# Site Accessibility Evaluation

### **Costilla Parking Garage**

**Accessibility Evaluation**

***Inspection Date: 08/05/2019***

Finding 297249 Main Photo

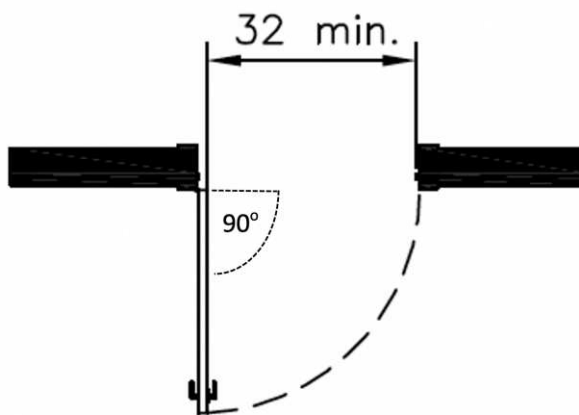
The door opening does not provide at least 32 inches between the face of the door and the opposite stop.

25.25 inches in width.  
Door located on  
northeast corner of  
Tejon and Costilla

Install door frame and door that provides a minimum width of 32 inches. Projections into the clear opening width between 34 inches and 80 inches above the finish floor or ground shall not exceed 4 inches.

Finding #3 Continued

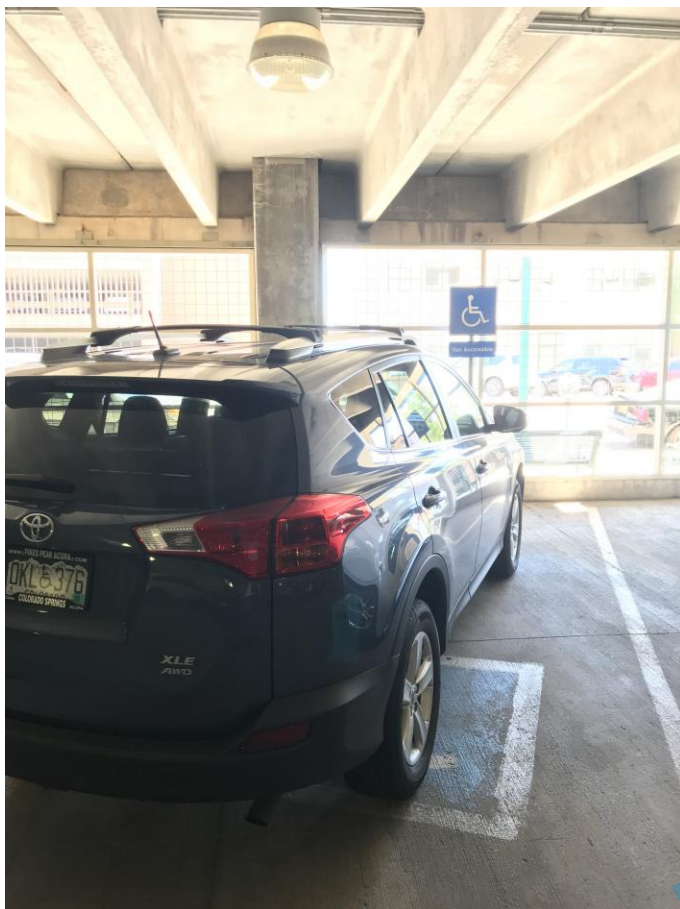
The access aisle is missing at the accessible parking stall.

Access aisle missing  
for 2nd accessible van  
parking stall

Re-configure striping to ensure 2 van stalls with 2 access aisles to the right of each van stall and 7 accessible parking stalls with a 5 foot access aisle. Since parking stalls are angled, each van stall must have its own access aisle located on the passenger side. Non-van accessible stalls may share an access aisle or van access aisle and access may be located on either side of the vehicle.

Finding #5 Continued

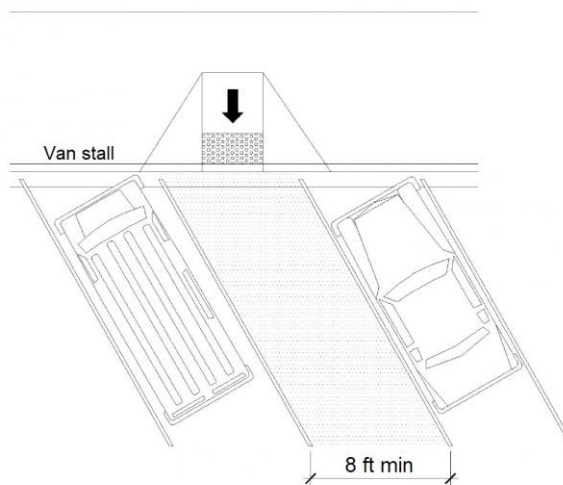
The access aisle is on the driver's side of the stall.

Access aisle on driver's side (angled parking stall)

Remove "van accessible" signage from 2nd stall. Van access aisles must be on passenger side for angled parking stalls.
